Response to Council Request for Information DA35/2024/2

1 Gatacre Avenue and 1-5 Allison Avenue,
Lane Cove

GATACRE LC PTY LTD

Figure 4. Section through Building A showing Height Exceedances
Source: PBD Architects

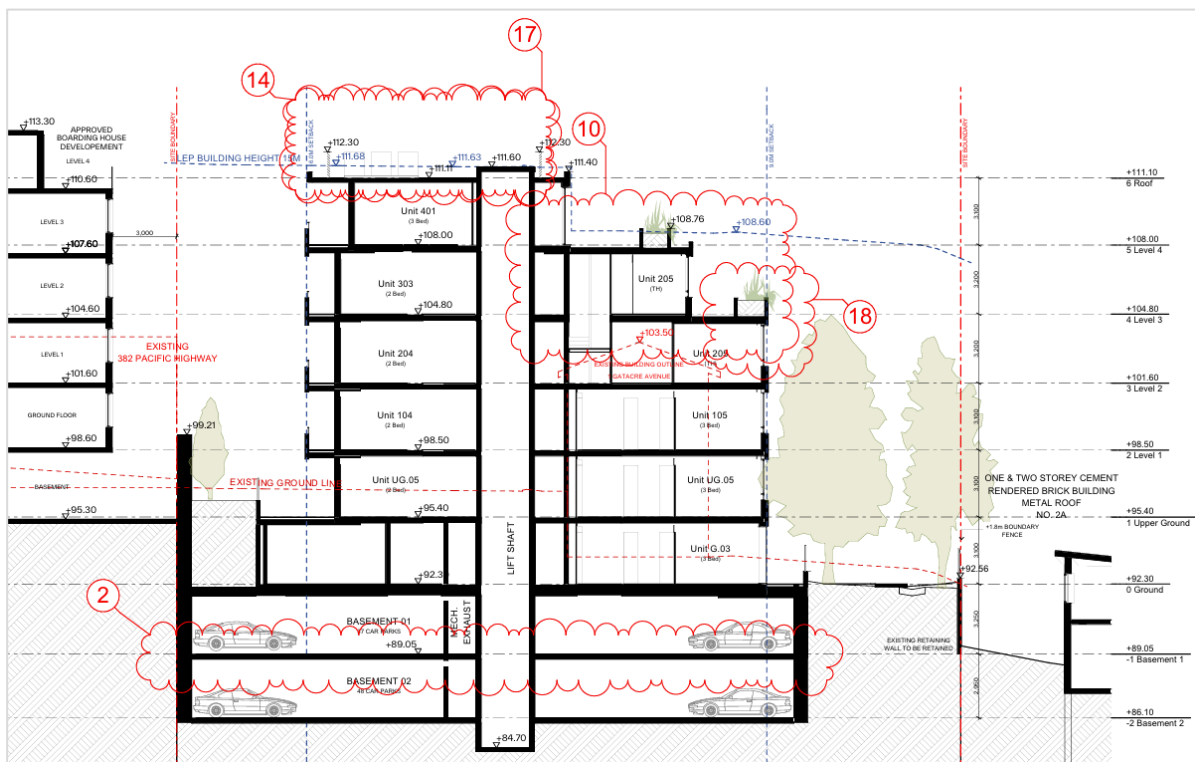
A key concern raised in the public submissions was that this modification would introduce a minor contravention of the 15m the maximum height of building (HOB) development standard as prescribed by the *Lane Cove Local Environmental Plan 2009* (LCLEP 2009) resulting from the:

- Relocation of the air conditioning units from Level 3 to the rooftop of Building A; and
- Conversion of the previously non-trafficable terraces into private balconies which results in the proposed balustrades exceeding the height plane in some locations.

Nevertheless, the height of the rooftop plant area has been lowered from 1.8m to 1.2m which reduces the height exceedance by 600mm. As such, the revised maximum building height would be **15.69m**, representing a **4.6%** variation to the standard, as shown in Figure 3. This height exceedances are limited to rooftop plant and screening, and will not be perceptible from the public domain, as shown in Figure 4.

The proposed height exceedance relating to the Level 4 balustrades of up to 160mm representing a 1% exceedance of the maximum HOB. This exceedance reflects the existing ground level changes of the site which have a more than 2m level change close to this area, as shown in Figure 4.

Figure 6. Sightline Diagram - Southern Private Open Spaces
Source: PBD Architects

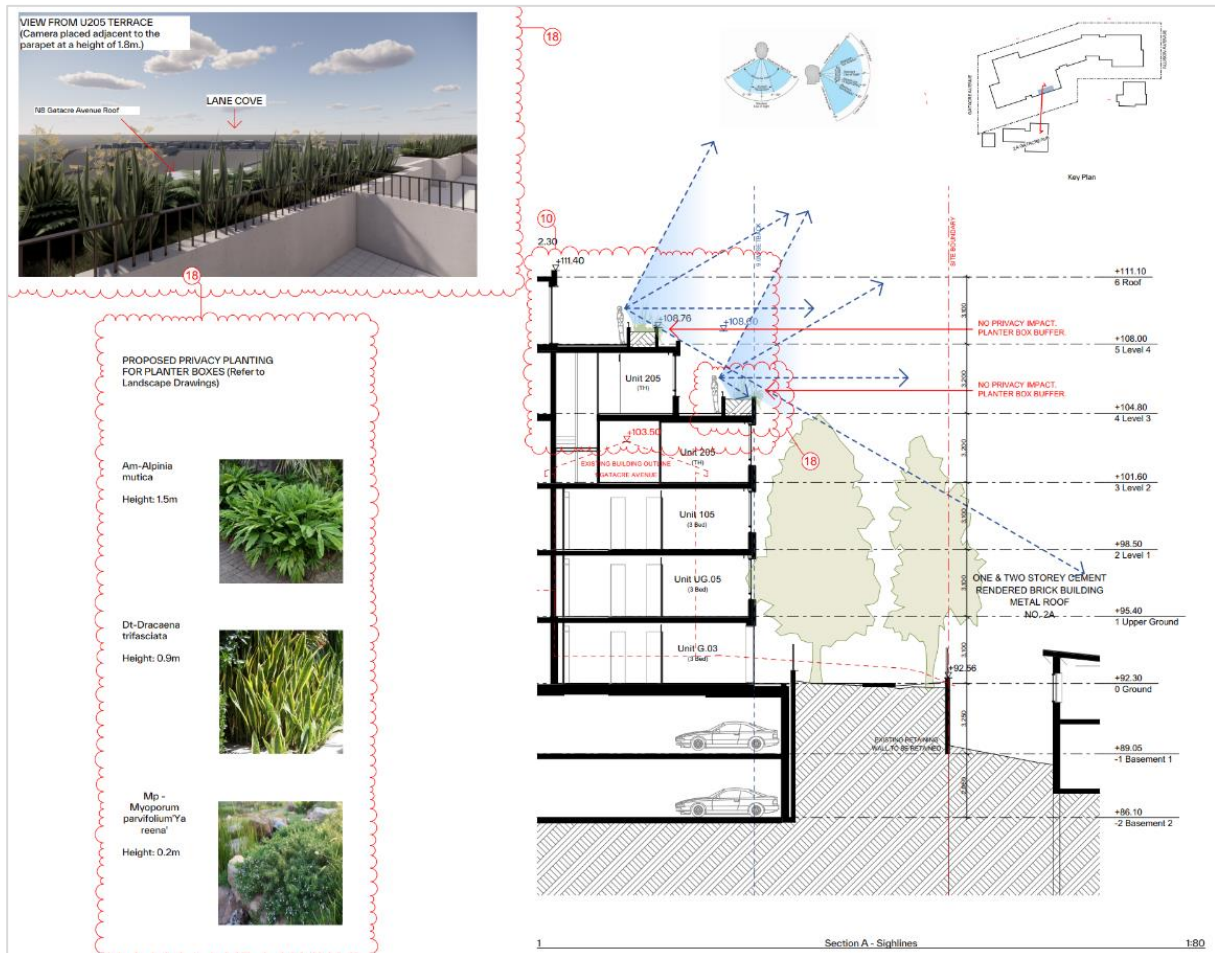
The s4.55(2) modification application seeks to convert the previously non-trafficable terrace on Level 3 and Level 4 of Building A, into a private open space for Units 205, 302, 401, and 402. This modification raised concerns regarding the privacy and amenity of properties adjacent the development.

Potential privacy intrusions was a key concern raised within the submissions, specifically relating to the terrace modifications, expansion of Unit 205, and the revised window treatments.

The proposed Level 3 planter boxes have been widened by 350mm to ensure that anyone using the terraces will not have direct lines of sight into the backyards or windows of habitable rooms of the neighbouring properties. As such, it will not result in any noticeable privacy, amenity, visual, solar access, noise, or overshadowing impacts.

Figure 5 demonstrates that the first dwelling visible from Unit 205's Level 3 terrace will be the roof of 8 Gatacre Avenue almost 60m away from the terrace. Figure 5 and Figure 6 demonstrate that the sightlines from these new terraces will not intrude on the privacy of neighbours.

As discussed in Section 3.3 of this Report and demonstrated in Figure 6, the proposed terrace modifications will not result in any loss of privacy or amenity to adjacent properties. The design and treatment of the balconies ensures that there will be no direct lines of sight into the backyards or habitable rooms of neighbouring properties. These balconies are envisioned to be used for passive, private uses that will not generate unacceptable noise levels. Furthermore, this change will not alter the built form, scale, bulk, or setbacks of the development and will not create additional overshadowing impacts or impede solar access.

Figure 7. Sightline Diagram for Southern Oblique Windows
Source: PDB Architects

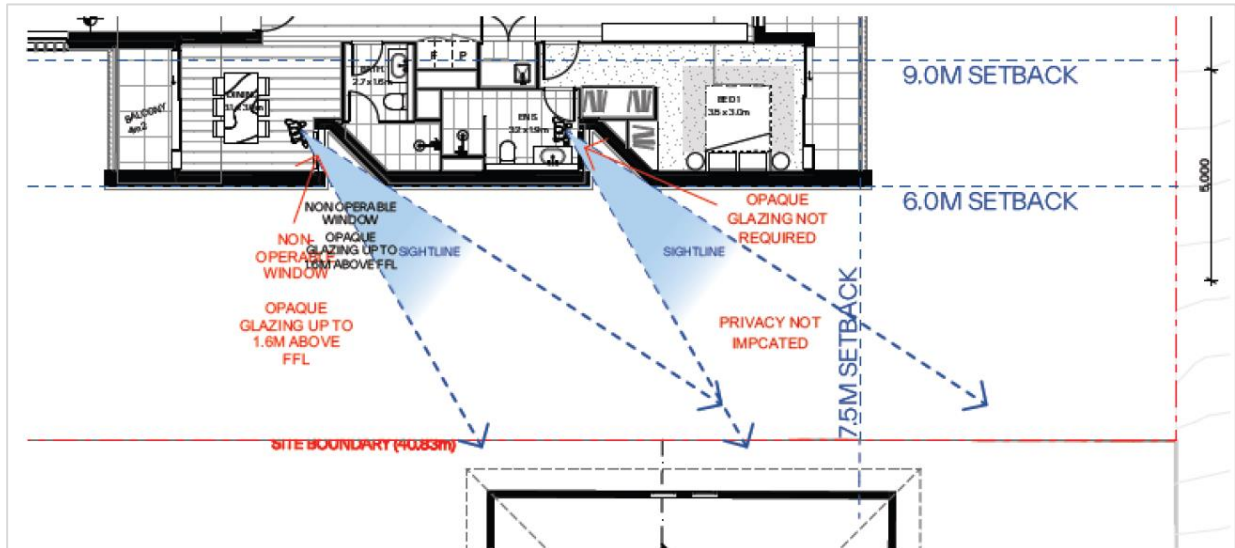
The s4.55(2) modification application included a request to modify Condition 2A to apply only to habitable rooms along the southern external walls. This proposed modification is considered reasonable as only the oblique, diagonal facing windows from habitable rooms along the southern external walls require privacy measures. The oblique windows from the ensuite bathrooms in their current form (as operable with clear glazing) will not impact the privacy of residents at 7 Allison Avenue.

Figure 7 below clearly shows that views from the ensuite bathrooms do not allow for sightlines into the windows of 7 Allison Avenue and thus do not require privacy measures. Accordingly, the requirement for Condition 2A need only apply to **habitable rooms** with oblique, diagonal facing windows along the southern external walls. The privacy of residents at 7 Allison Avenue will not be impeded by this proposed modification.

Figure 9. s4.55(2) Modified Plan - Level 2 Floor Plan (Unit 205)
Source: PBD Architects

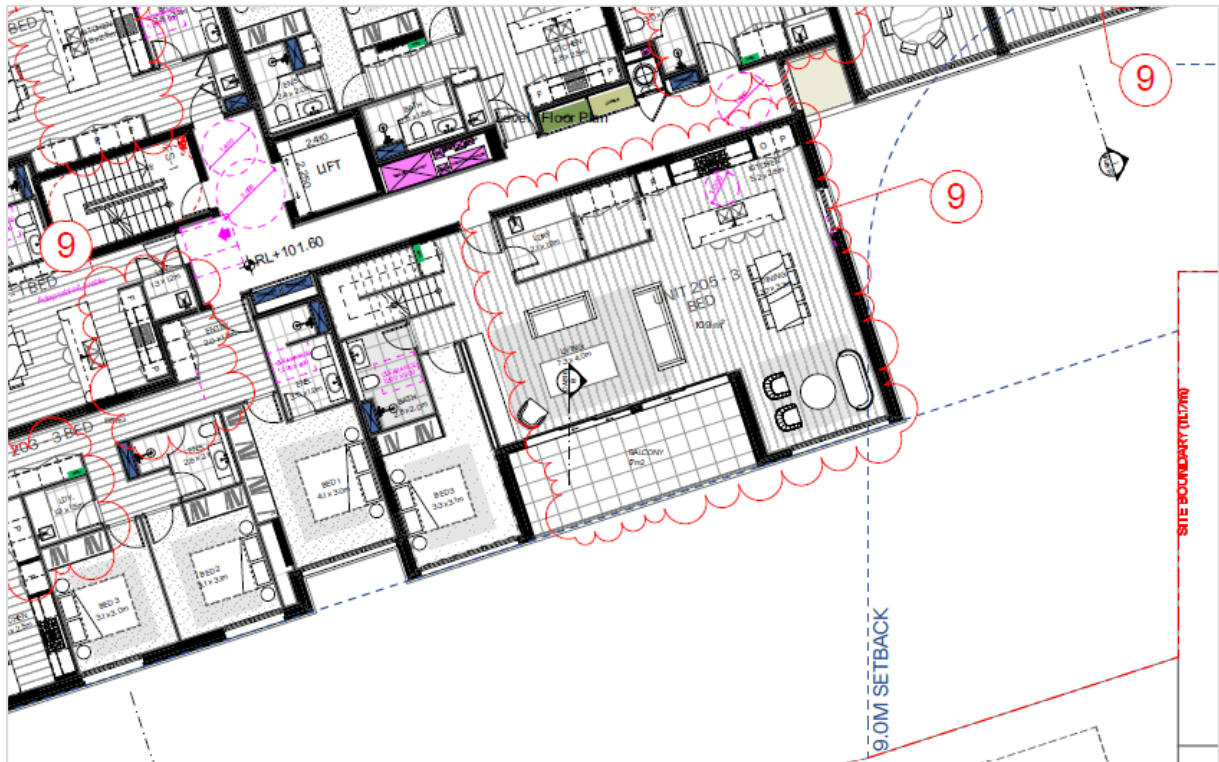
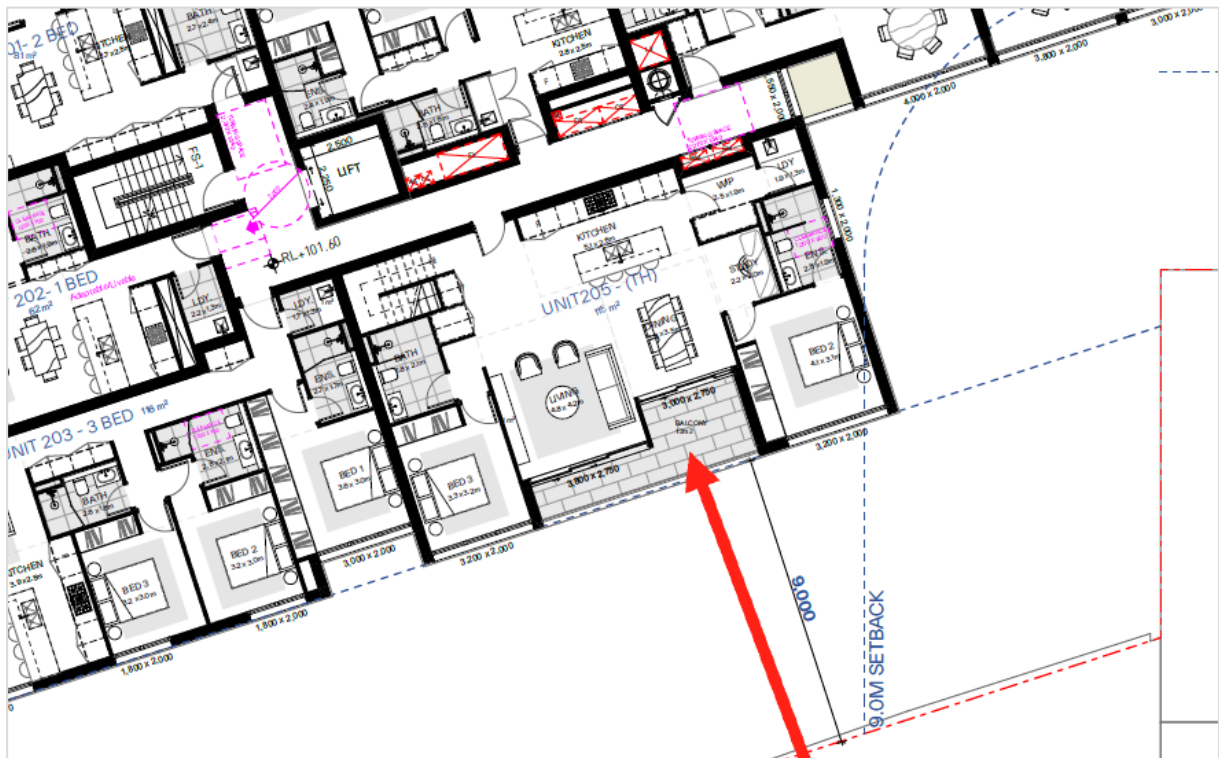
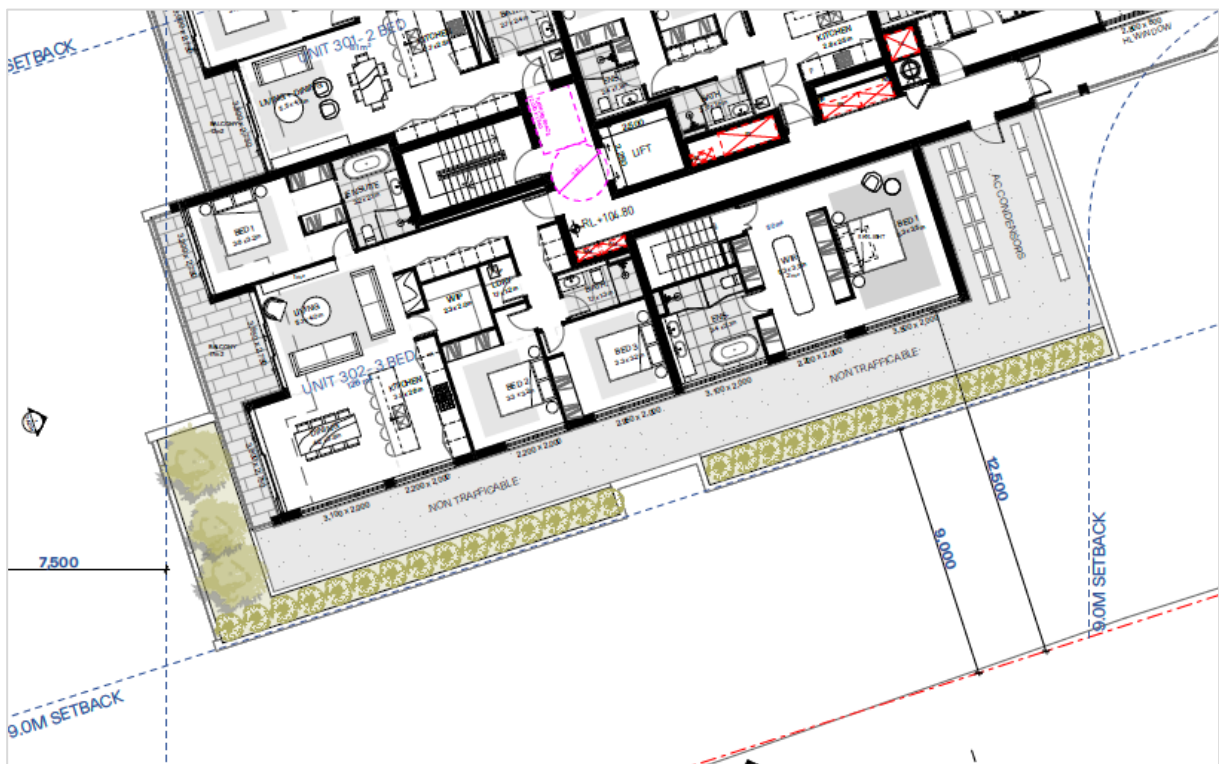
Another concern raised was that the expansion of Unit 205 would result in a noticeable change in built form, creating increased overshadowing, increased building bulk and loss of visual amenity. As demonstrated in Section 3.11.2 of this Report, the proposed expansion of Unit 205 does not result in any significant changes to the scale or setbacks of the building. This proposed change will ultimately not increase the visual dominance of the building or result in unacceptable visual, amenity, overshadowing, or solar access impacts to neighbouring residences.

As previously noted in Section 3.3 of this Report, although the use of the space results in a technical non-compliance against the ADG, the built form setbacks remain unaltered, and the proposal remains compliant with Part C of the LCDCP 2010. This is demonstrated by Figure 9, Figure 10, Figure 11, and Figure 12 below.

The relocation of the air conditioning units is not related to the expansion of Unit 205.

Figure 13. Modified Plan DA106
Source: PBD Architects

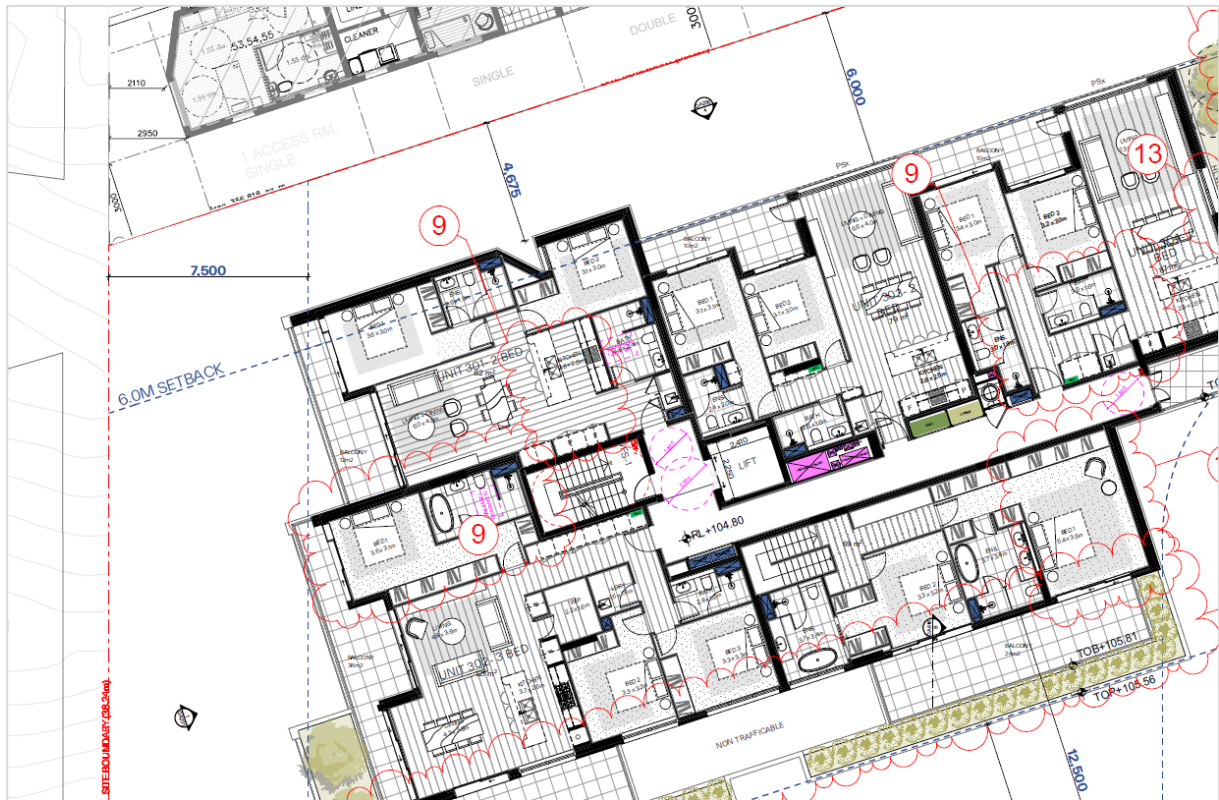
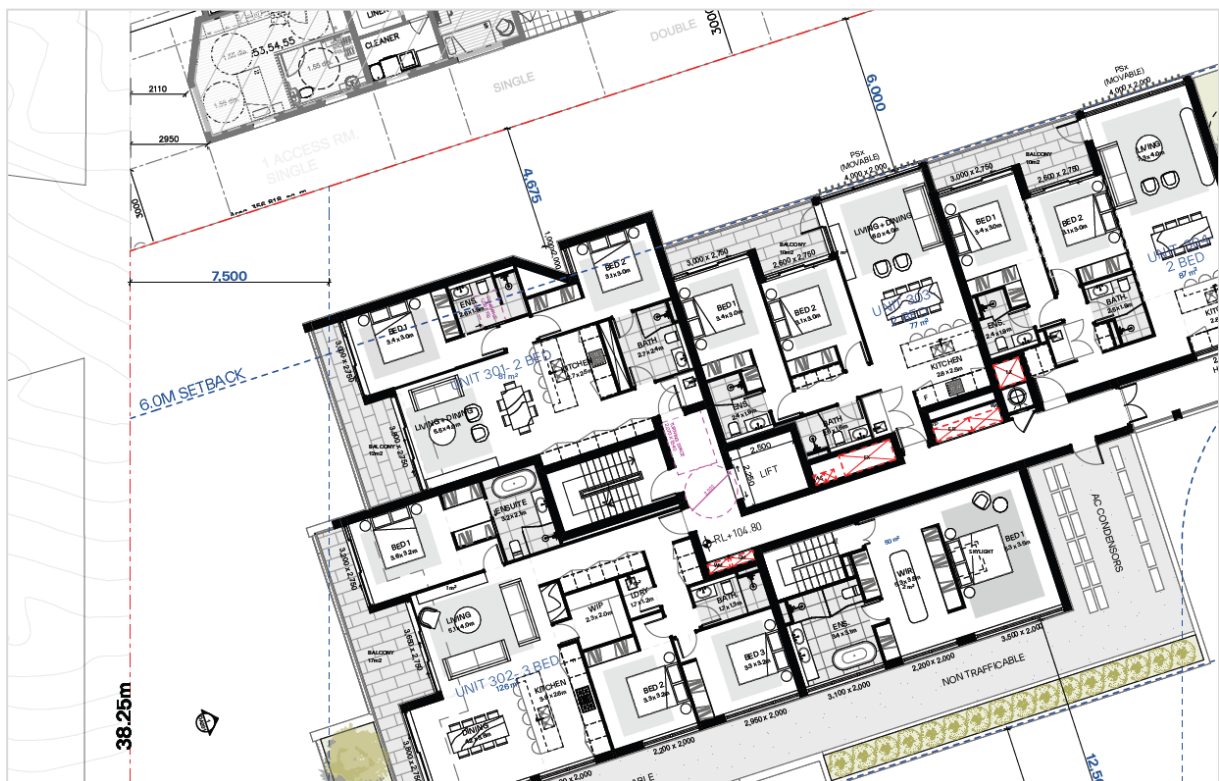
One (1) objector raised concerns that there were errors in the prepared Architectural Plans supporting the modification application. Specifically, the objection incorrectly claims that:

- Approved plan DA105 shows Units UG01, 101, 201, 301 and 401 with different northern walls to the approved plans;
- The proposed modifications do not indicate the distances to the site boundary; and
- Apartment 401 is depicted differently in the modified plans compared to the approved plans.

As demonstrated in Figure 13 and Figure 14, these errors were misidentified and in fact there have been no changes to the approved northern walls for Unit UG01, 101, 201, 301 and 401, or reduction in the approved 4.675m distance to the northern boundary.

Figure 15. Sightline Diagram for Southern Balconies
Source: PBD Architects

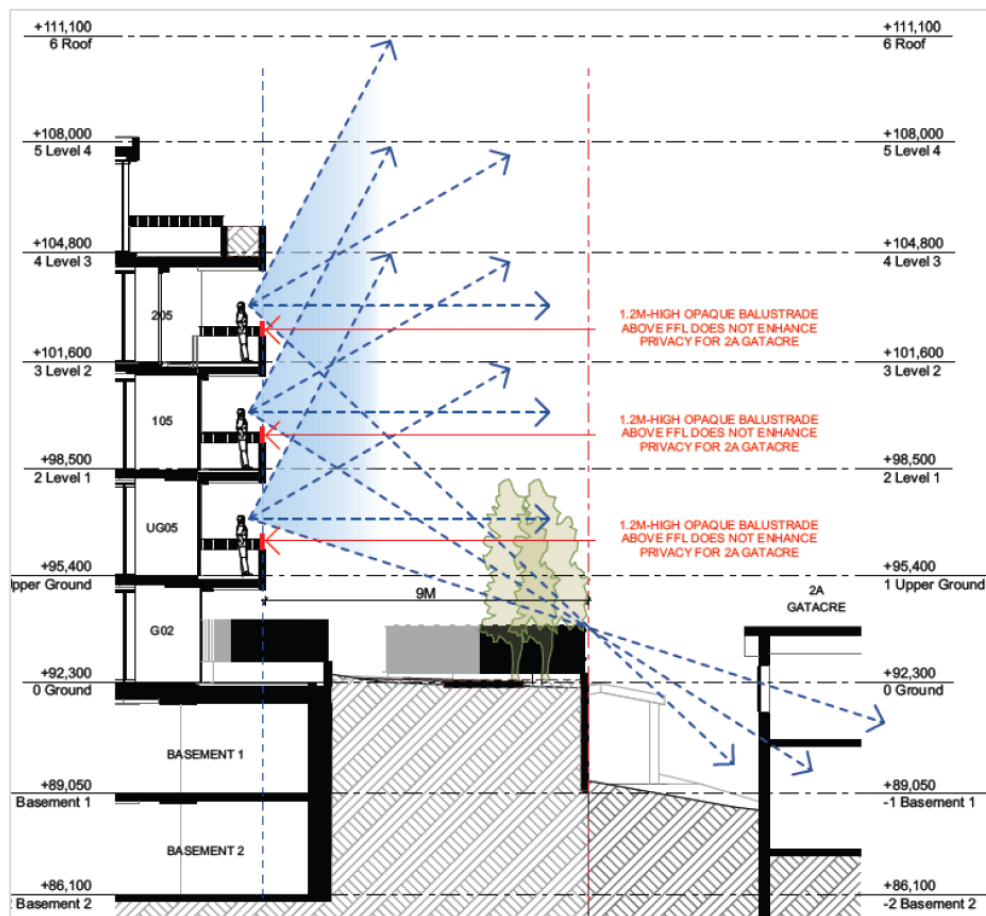
One (1) objector raised concerns regarding the proposed modification of the balustrades along the south facing balconies.

Condition 2F of the consent requires the balustrades of the south facing balconies of Units UG.05, 105 and 205 to be constructed with solid obscure finishes up to 1.2m above FFL. As demonstrated in Figure 15 below, the proposed treatment would not alter or enhance the privacy of residents at 2A Gatacre Avenue. Further to this, the removal of this condition would not result in additional noise pollution or amenity loss. The development would still comply with Part 3F of the Apartment Design Guide relating to visual privacy which requires a balance between a need for views and privacy.

As such, the provision of solid obscure finishes at these south facing balconies would not improve privacy or amenity for neighbouring properties and this treatment would undermine the design intent of the development.
